MAJOR PROJECT ASSESSMENT

MP 09_0148

***Meriton Multi Unit Residential Development
12-40 Bonar Street & 5 Loftus Street, Arncliffe
Proposed by: Meriton Apartments Pty Ltd***

Director-General's Environmental Assessment Report
Section 75I of the Environmental Planning and Assessment
Act 1979

Figure 7: Council's maximum building heights across the subject site.

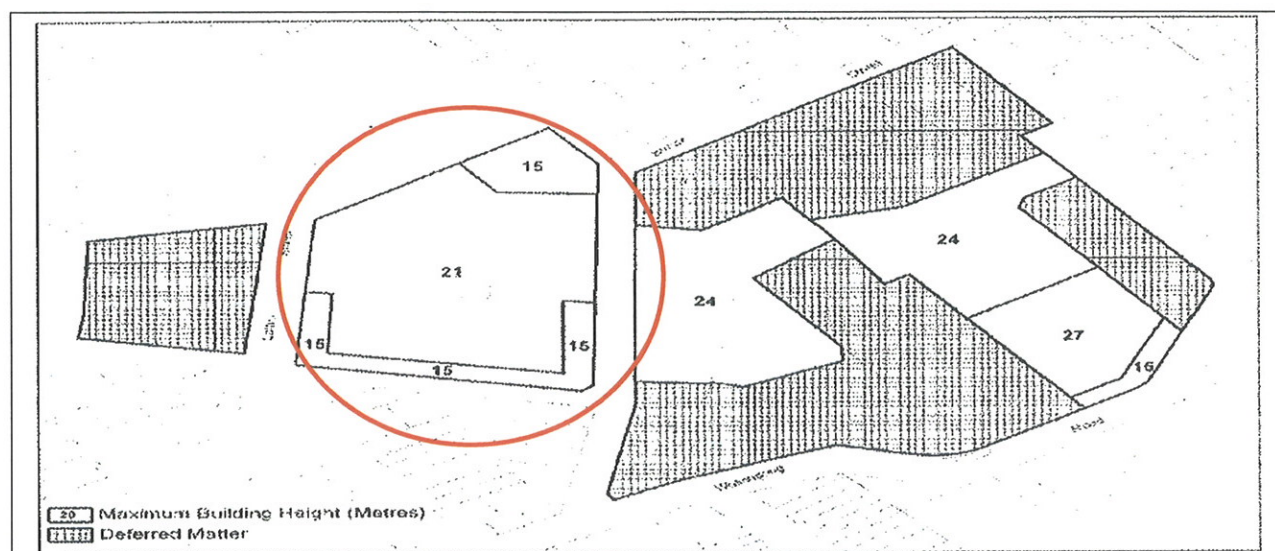
Further, Council's controls allow for an additional height of 3m (24m max.) over any part of the site, but only if the consent authority is satisfied that such variation will not have an adverse material effect on the amenity of occupants of nearby land.

The Proponent seeks to utilise the additional 3m height for buildings A and D of the proposal (refer **Figure 8**). Buildings A and D will have a total height of 24m, however it is noted that roof top plant and parapets on buildings A and D exceed the maximum 24m height limit by 1m. Buildings B and C project 1m above Council's standard height control of 21m however are well within the maximum height limit of 24m.

Figure 8: Additional height to Building A and D shaded blue. Distance from closest affected residents (Knoll Avenue) is highlighted in orange.

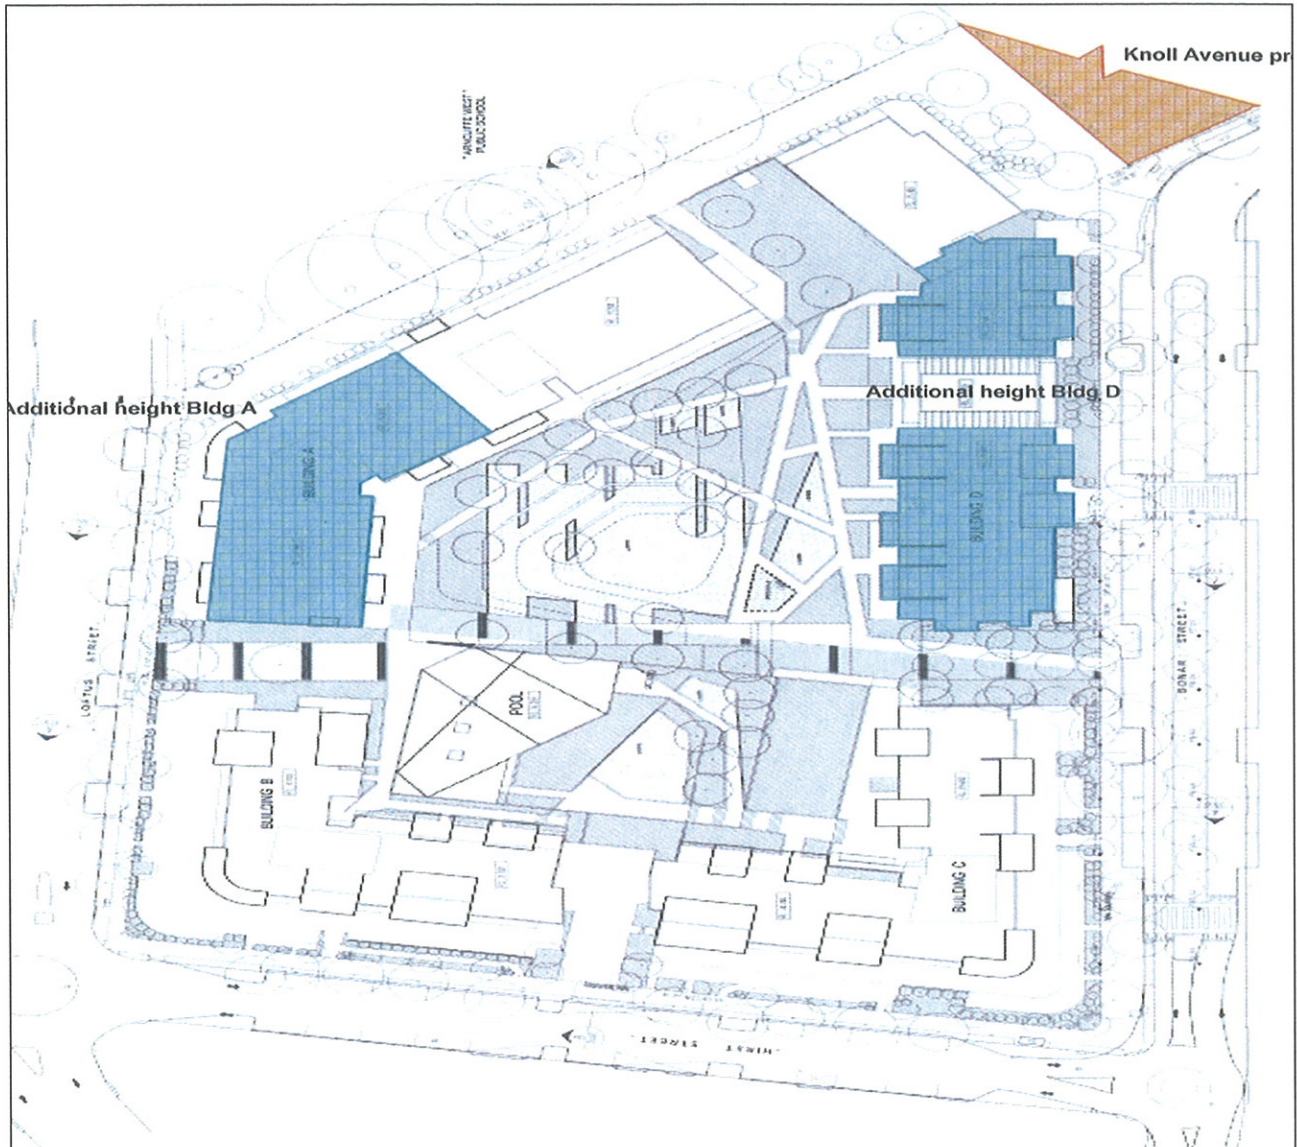
The Department notes that a minor height variation is sought where the rooftop plant and parapets exceed Council's maximum 24m height controls by 1m on Buildings A and D. However, the Department considers that the roof top plant is sufficiently setback from building edges and is appropriately screened to mitigate any visual or amenity impacts arising from the minor non compliance. Furthermore, the parapets form part of the overall design of the building and the height is consistent with the height controls opposite Bonar Street which sets a height limit of 24m and up to 27m further to the east.

On balance, the Department considers the additional height is acceptable. As discussed above, the additional height will have minimal impacts on the amenity of occupants of nearby land. Furthermore, the proposed maximum height (25m) is considered to be consistent with the desired future character of Bonar Street Precinct which allows heights ranging from 24m to 27m directly opposite the site to the east. The additional height is therefore supported.

Figure 9: Northern property boundary length to Building D adjoining residential properties in Knoll Avenue.

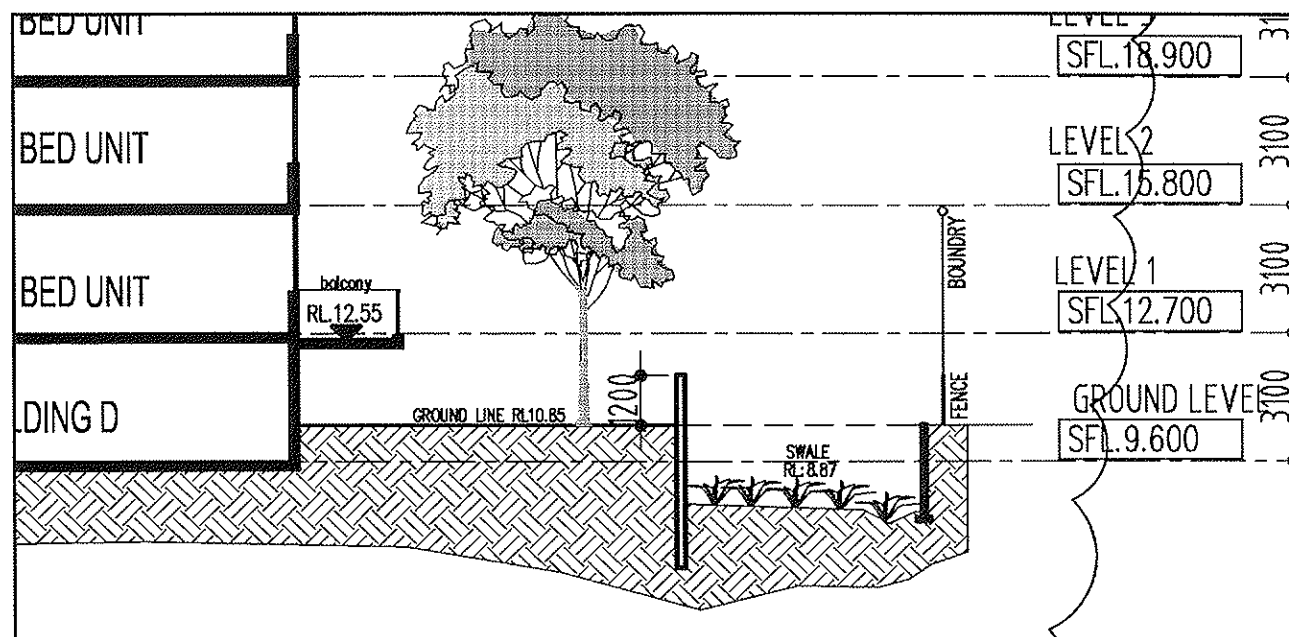
Rockdale Council and the Department both raised concerns with the height of the basement car park on frontages where it is elevated above ground level. The basement projection ranges between 1.2m and 1.6m above the ground level along Bonar Street and 1.8m and 3.4m along the northern property boundary shared with the school and Knoll Avenue residents. This has the potential to add unnecessary height to the building and a poor presentation to the street.

Where the basements are elevated above natural ground level and the proposal does not require clearance for flood protection, particularly for Buildings A and D, there is scope to reduce the

basement height. This will reduce the overall height of the building and will further minimise amenity impacts on surrounding properties, particularly overshadowing and privacy impacts. A condition is therefore recommended limiting basement projection to 1m above the proposed natural ground level along the property boundary shared with Knoll Avenue residents (Building D) and Arncliffe school (Building A). Subject to the above conditions, the Department considers the basement projections are acceptable.

In the PPR response, the proponent provided further justification noting that the basement car park is raised above street level along the Bonar Street frontage and a small part of the Hirst Street frontage to address the 1:100 year flood level. Further, additional landscaping is proposed along the Bonar Street frontage to better screen the elevated parking area.
